ADA Curb Ramp New Construction Inspection Form (Parallel)

Main North-South Road Name 24952.54 Project No. Sheet No. Intersection No. Hillcrest East-West Road Name

PARALLEL RAMP (PL)

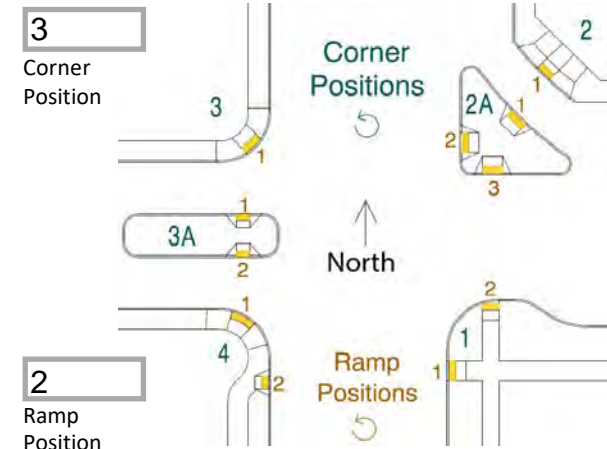
RAMP RUN 1	Pass	Fail
Running Slope 1 <input type="text" value=""/> $\leq 2.0\%$ <input type="checkbox"/> $> 2.0\%$ <input type="checkbox"/>		
Cross Slope 1 <input type="text" value="5.9"/> $\leq 2.0\%$ <input type="checkbox"/> $> 2.0\%$ <input checked="" type="checkbox"/>		
Detectable Warning <input type="text" value="Y"/> Y <input checked="" type="checkbox"/> N <input type="checkbox"/>		
Lip Height <input type="text" value="0"/> $\leq 1/4"$ <input checked="" type="checkbox"/> $> 1/4"$ <input type="checkbox"/>		
Gutter Flow Slope <input type="text" value="4.5"/> $\leq *$ <input type="checkbox"/> $> *$ <input type="checkbox"/>		
Curb Running Slope (avg) <input type="checkbox"/> <input type="text" value="6.64"/> $\leq 8.3\%$ <input checked="" type="checkbox"/> $> 8.3\%$ <input type="checkbox"/>		
Counter Slope (+/-)*2 <input type="text" value="8.3"/> $\leq 5.0\% $ <input checked="" type="checkbox"/> $> 5.0\% $ <input type="checkbox"/>

RAMP RUN 2	Pass	Fail
Running Slope 2 <input type="text" value="10.6"/> $\leq 8.3\%$ <input type="checkbox"/> $> 8.3\%$ <input checked="" type="checkbox"/>		
Length 2 <input type="text" value="7.8"/>		
Cross Slope 2 <input type="text" value=""/> $\leq 2.0\%$ <input type="checkbox"/> $> 2.0\%$ <input type="checkbox"/>

RAMP RUN 3	Pass	Fail
Running Slope 3 <input type="text" value="12.5"/> $\leq 8.3\%$ <input type="checkbox"/> $> 8.3\%$ <input checked="" type="checkbox"/>		
Length 3 <input type="text" value=""/>		
Cross Slope 3 <input type="text" value=""/> $\leq 2.0\%$ <input type="checkbox"/> $> 2.0\%$ <input type="checkbox"/>

IITD gt2. R3 asphalt
